ADDENDUM NO. 2

September 30, 2022

Woods Lake - A Magnet Center for the Arts Remodeling & Site Improvements

**Woods Lake Elementary
3215 Oakland Drive
Kalamazoo, MI, 49008**

1
A.801
1/4" = 1'-0"
**ALTERNATE No. 6
STAFF TOILET ENLARGED PLAN**

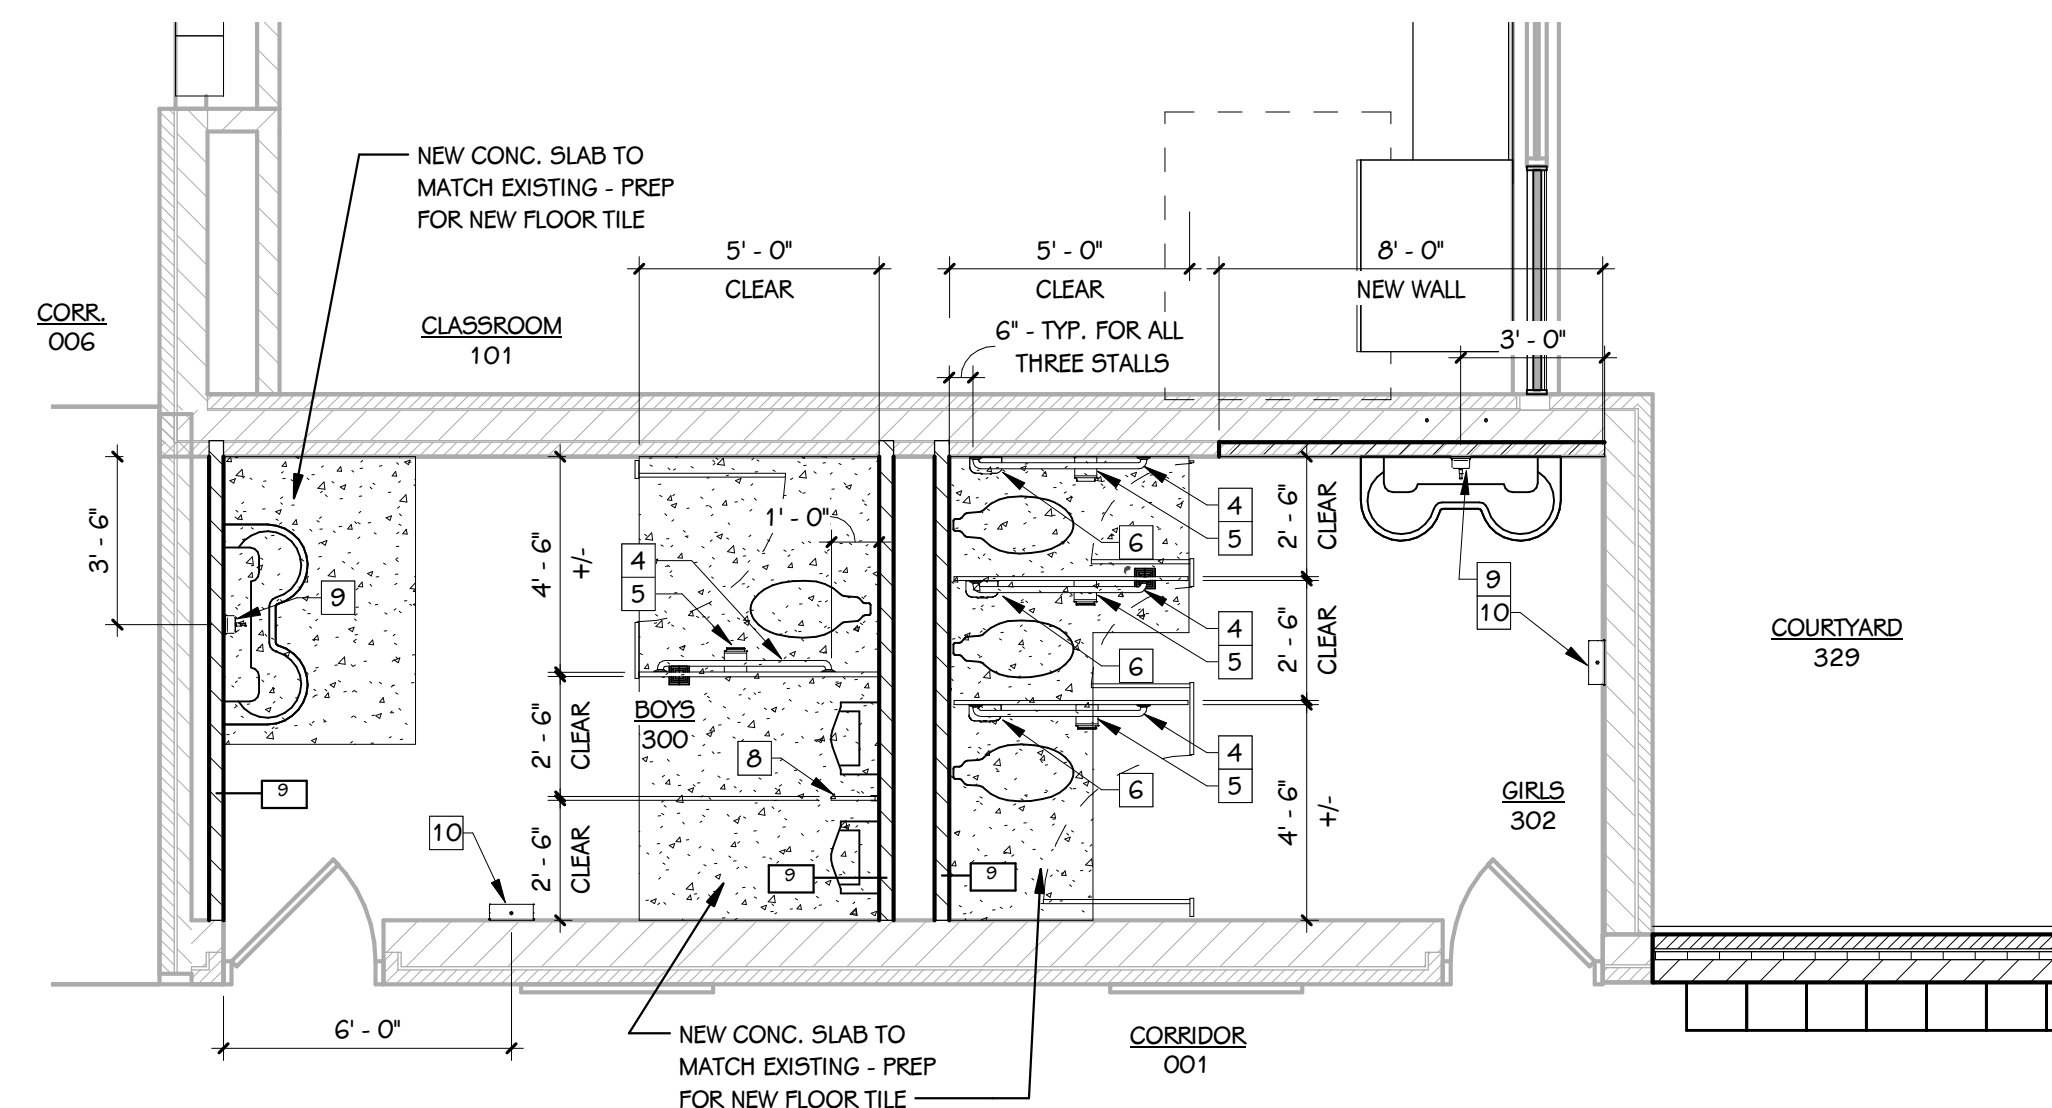
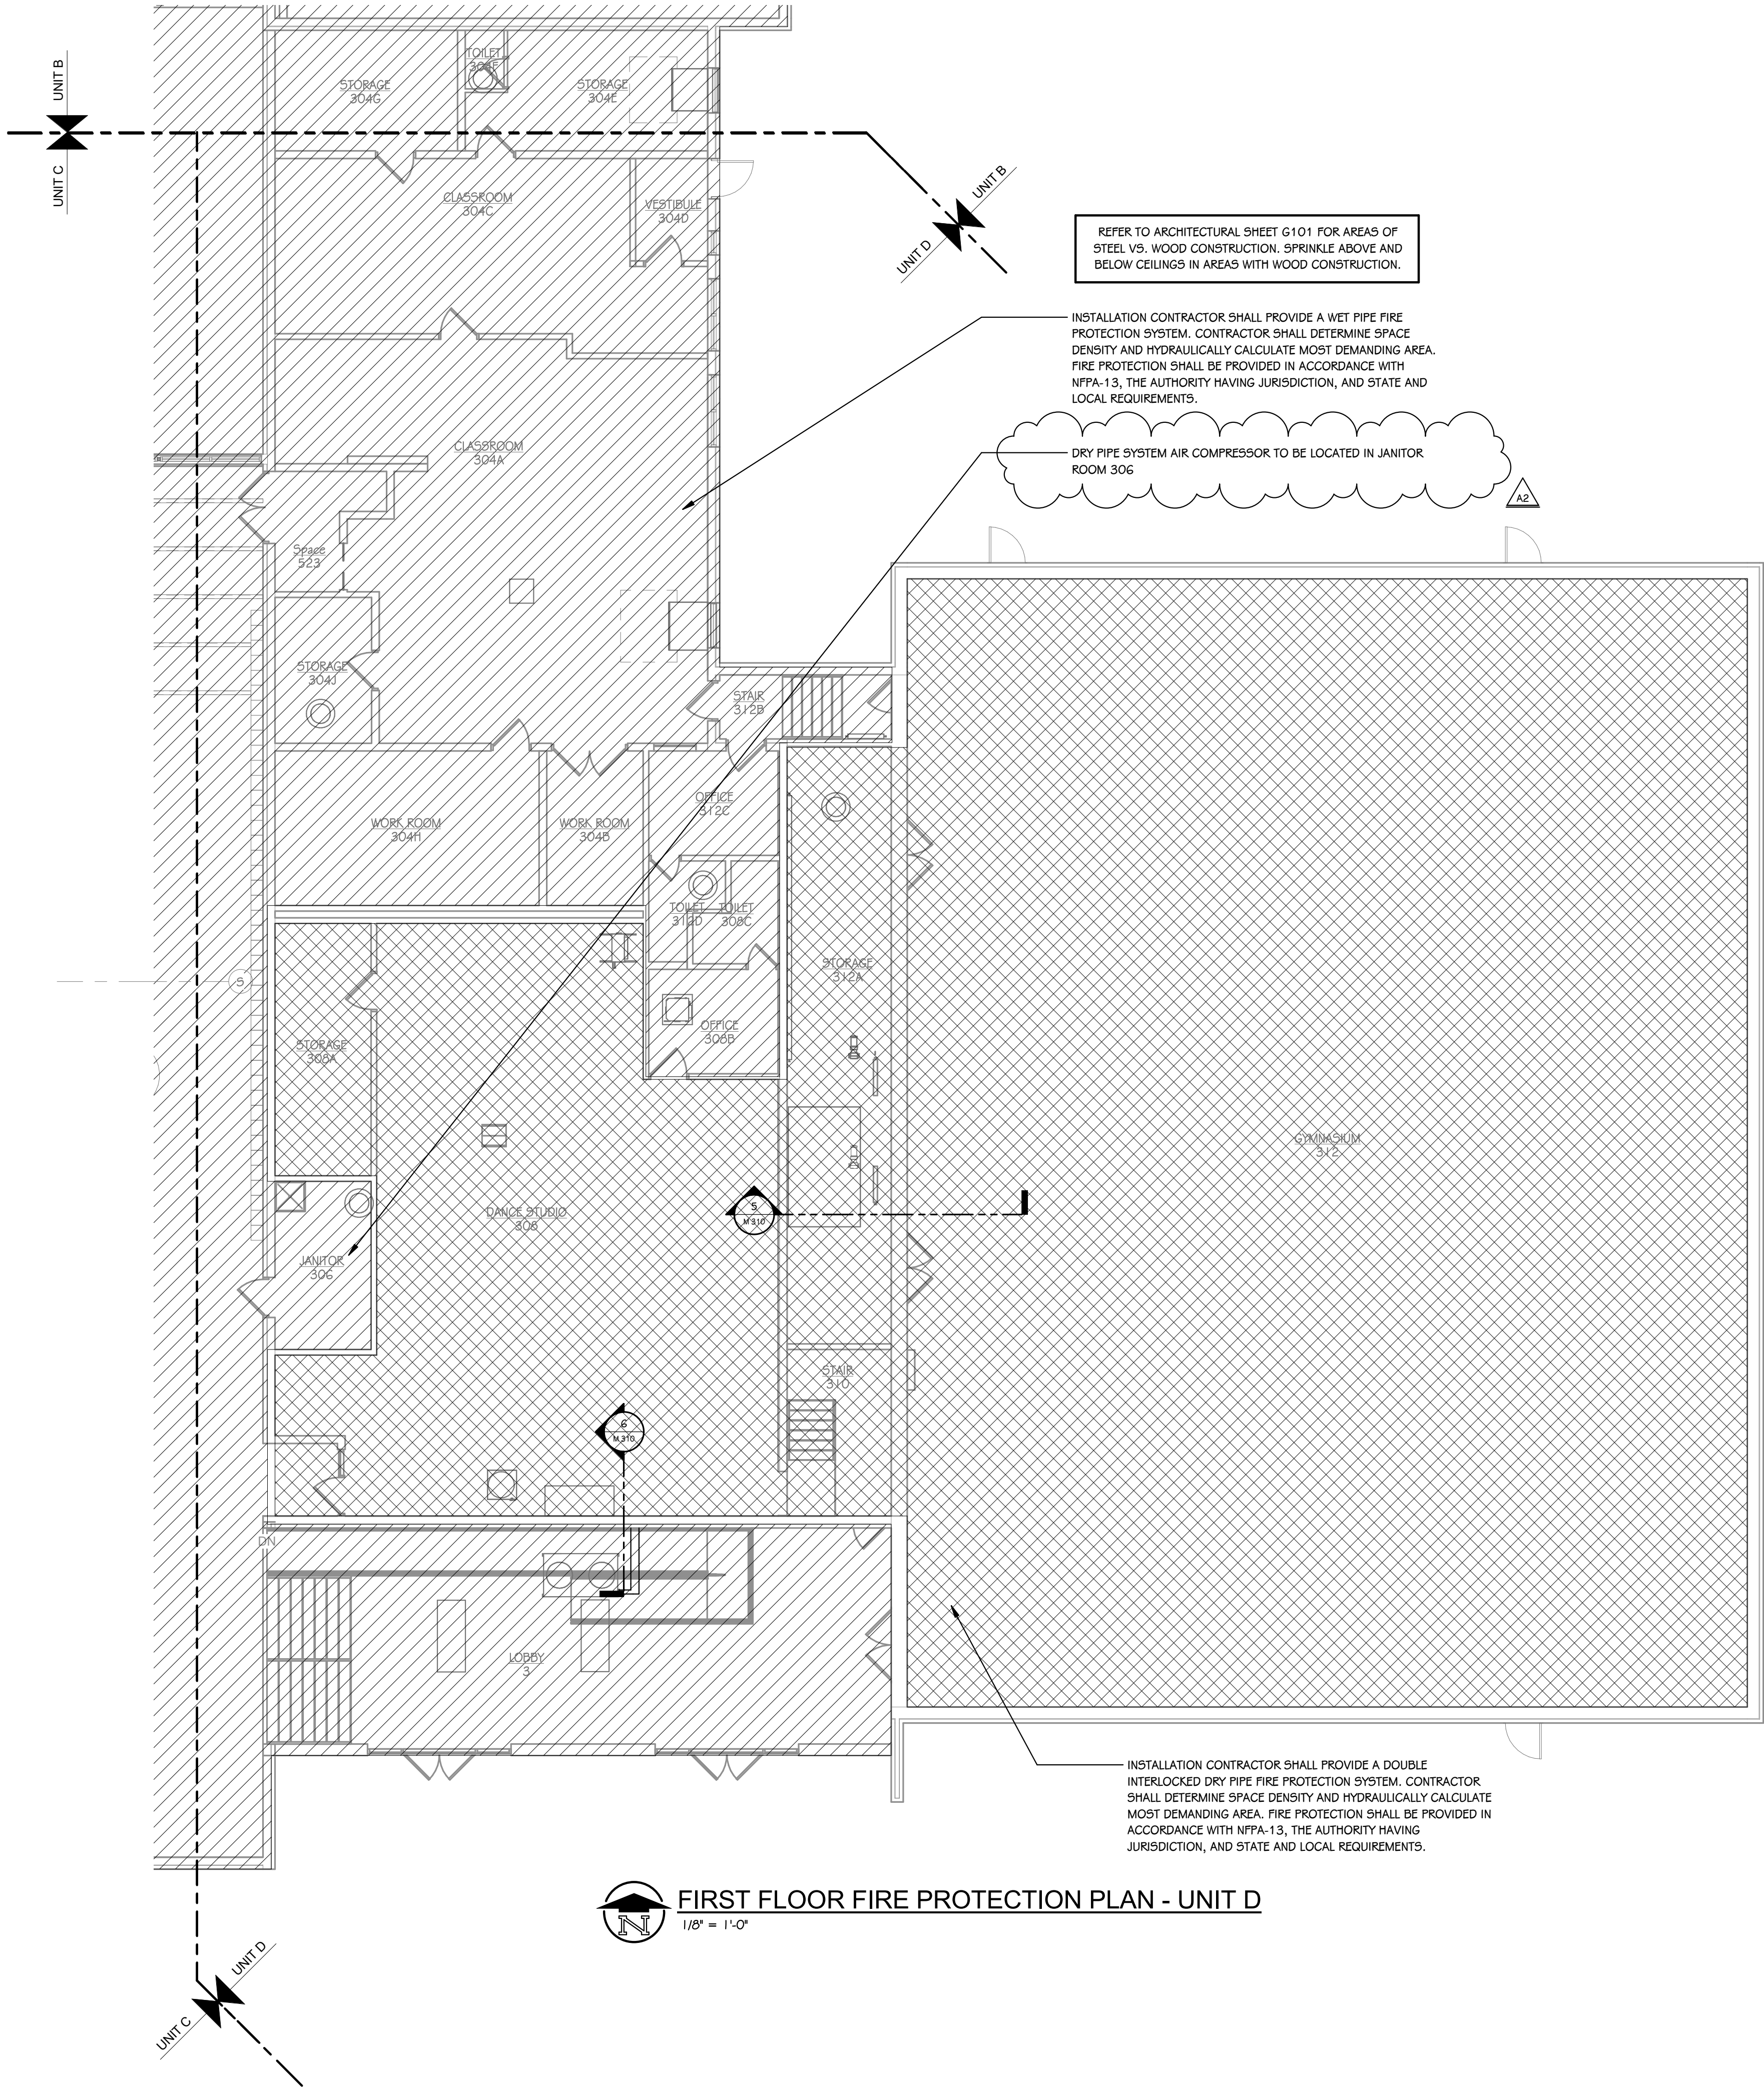
ADD-2 Item No. D-8 - Typical Toilet Room Mirror Size

Mirror size on drawing sheet A 801 was incorrectly noted as 18" W x 34" H. Correct size shall be 18" W x 36" H.

FIRST FLOOR HVAC PIPING PLAN - UNIT D - ALTERNATE No. 4
M 801 1/8" = 1'-0"FIRST FLOOR SHEET METAL PLAN - UNIT D - ALTERNATE No. 4
M 801 1/8" = 1'-0"

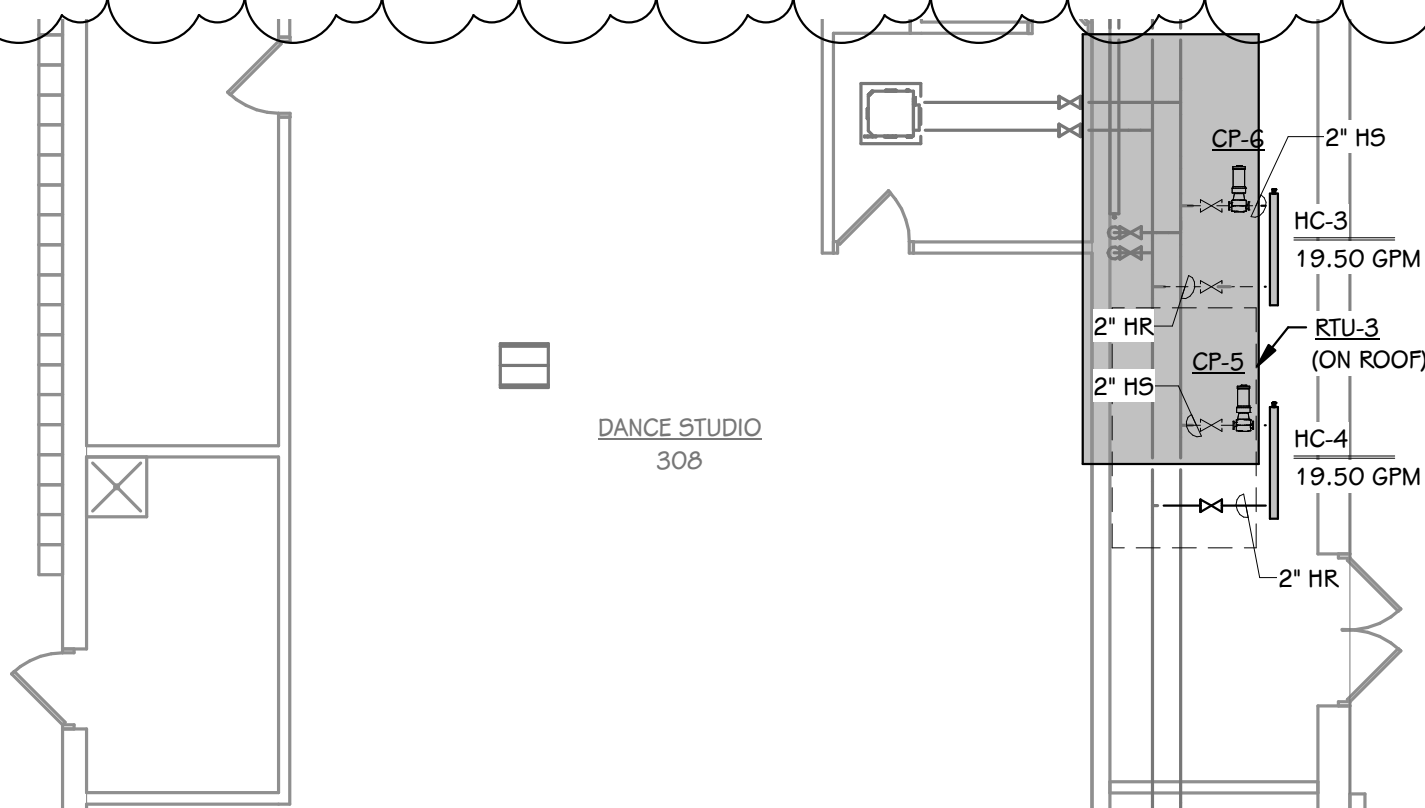
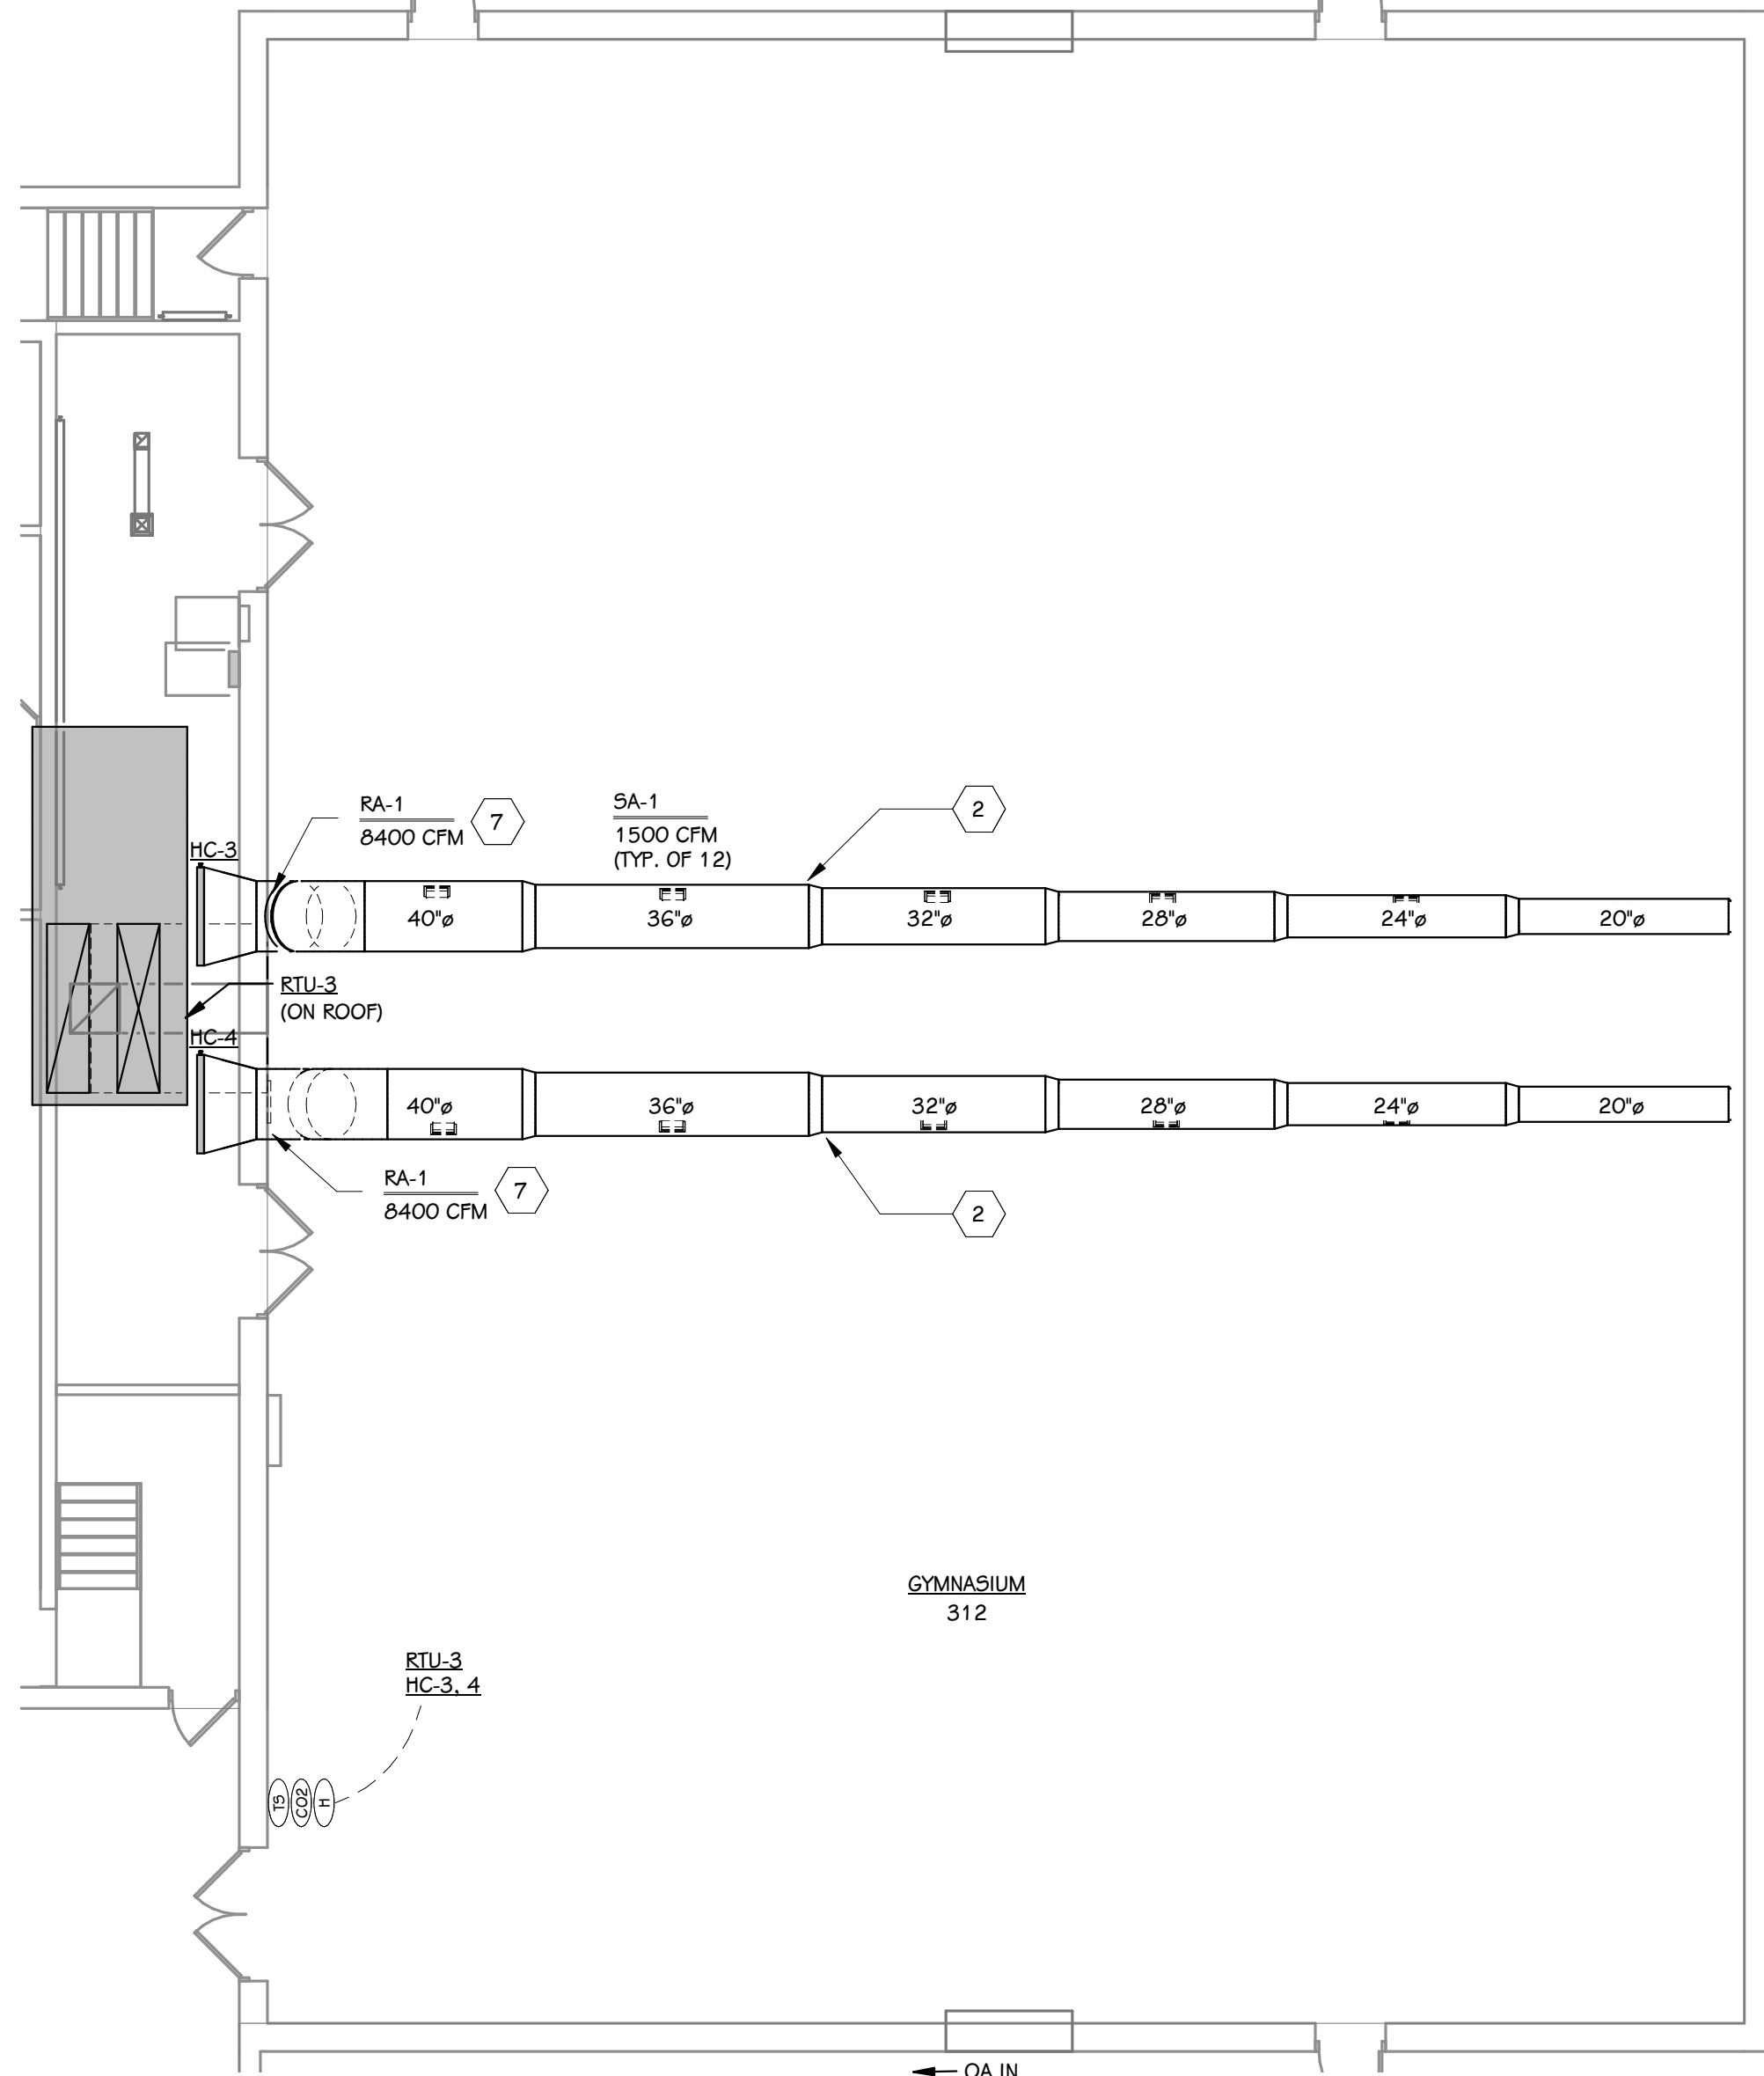
ADD-2 Item No. D-6 - Alternate Gymnasium AHU-3 Coils, Controls, and Dimensions

Added airflow monitor station for outdoor air intake. Updated unit footprint to match model number. Increased outdoor air capacity and heating coil and pump capacities.
